Designation: **G195—13a G195 – 18**

Standard Guide for Conducting Wear Tests Using a Rotary Platform Abraser¹

FIG. 2 Central Axis of the Turntable Arrangement of Rotary Platform Abraser Test Set-Up

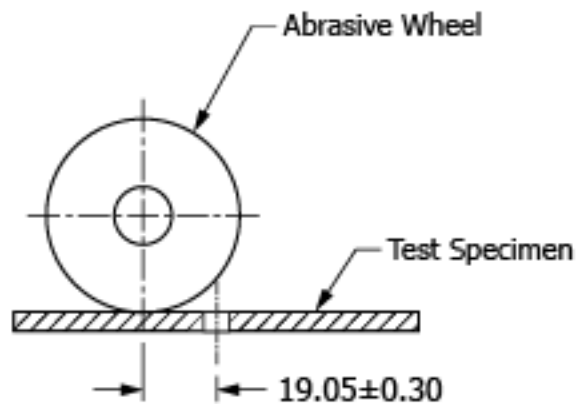
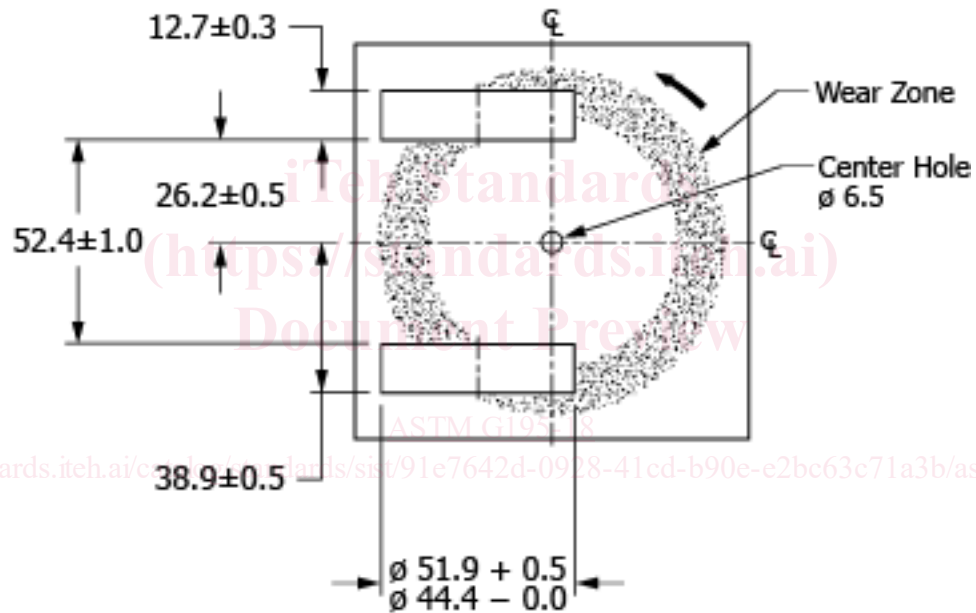
6.2.2 The internal faces of the abrasive wheels shall be 52.4 ± 1.0 mm apart and the hypothetical line through the two spindles shall be 19.05 ± 0.3 mm away from the central axis of the turntable (see Fig. 2). The wheels shall be spaced equally on both sides from the wheel-mounting flange to the center of the specimen holder. The distance from the inside of the wheel mounting flange to the center of the specimen holder shall be 38.9 ± 0.5 mm.
